ADDENDUM NO. 03

TO: PLANS AND SPECIFICATIONS FOR STATE OF MISSOURI

Replace Fire Alarm System, Infrastructure
Farmington Correctional Center
PROJECT NO.: C2503-01

1 BUILDING 17 - LEVEL 2 - FIRE ALARM
1/8" = 1'-0"

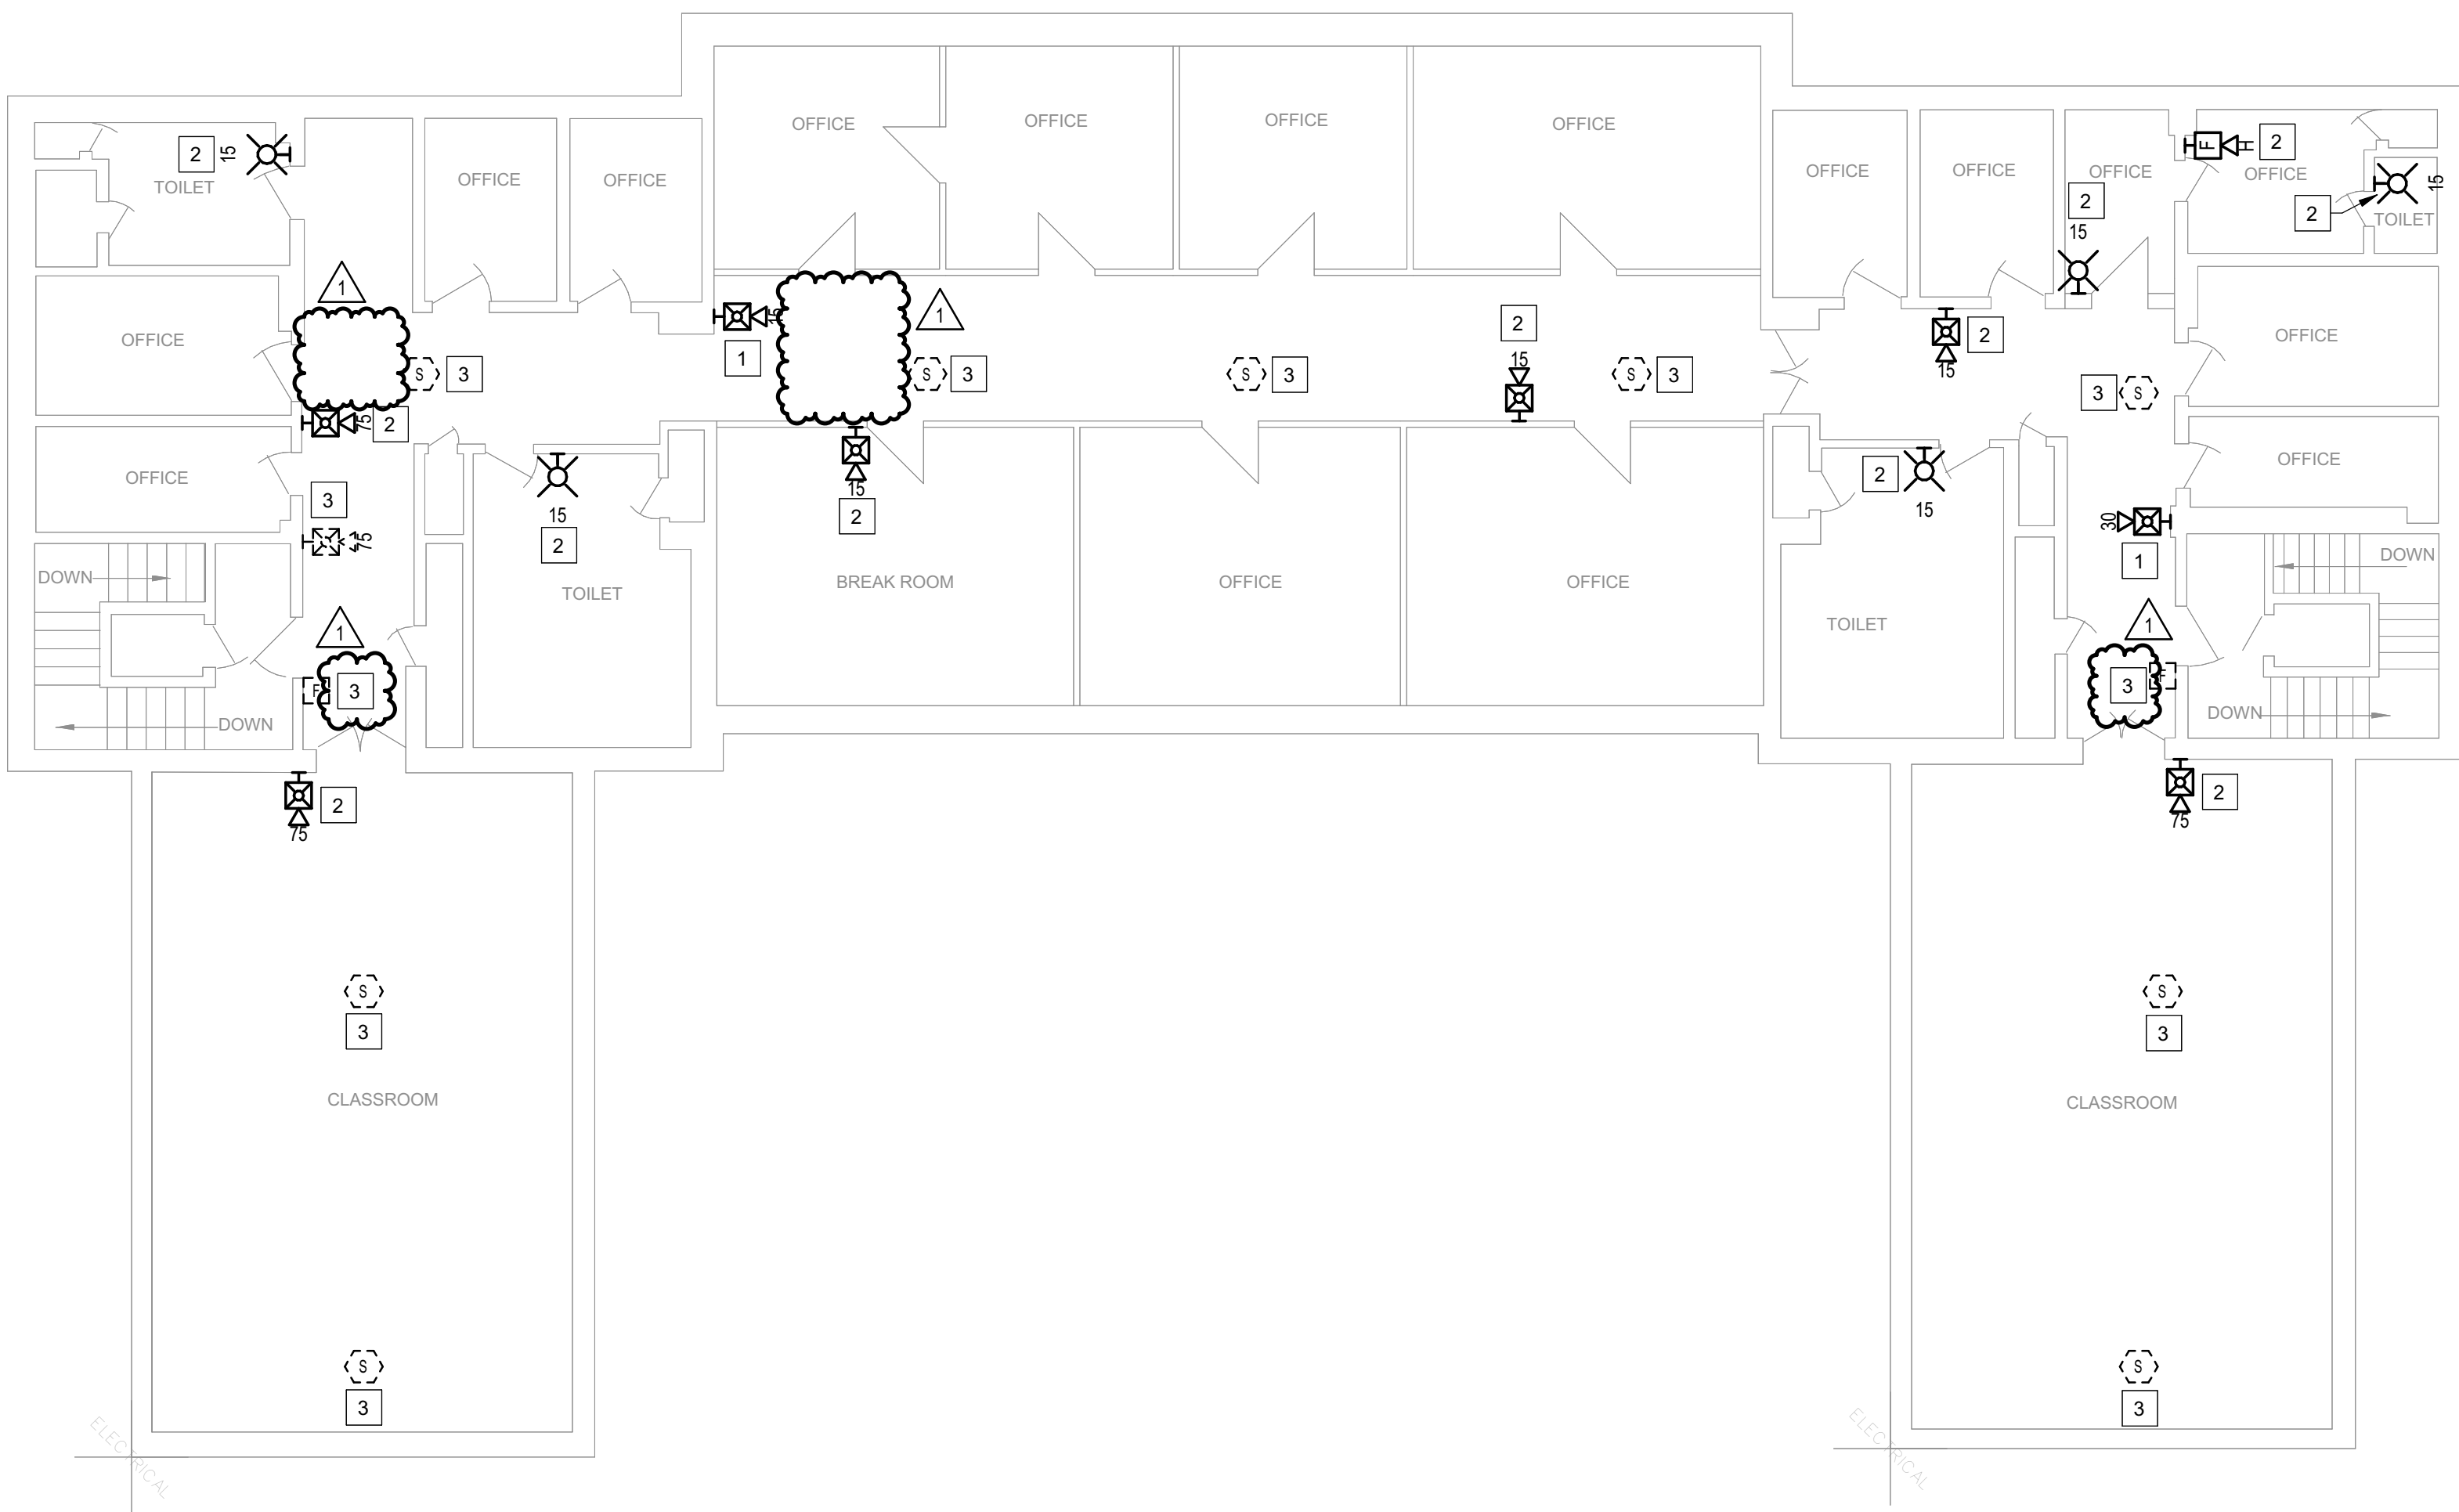
45. FA141 - BUILDING 17 - LEVEL 2 - FIRE ALARM
- a. GENERAL SHEET NOTE #2 REMOVED
 - b. SHEET KEYNOTE #4 REMOVED
 - c. NON-APPLICABLE DEVICES IN HALLWAY REMOVED.

- d. KEYNOTE ANNOTATION ON BOTH PULL STATIONS MODIFIED FROM 1 TO 3.
46. FA142 - BUILDING 18 - LEVEL 1 & 2 - FIRE ALARM
- a. GENERAL SHEET NOTE #2 REMOVED
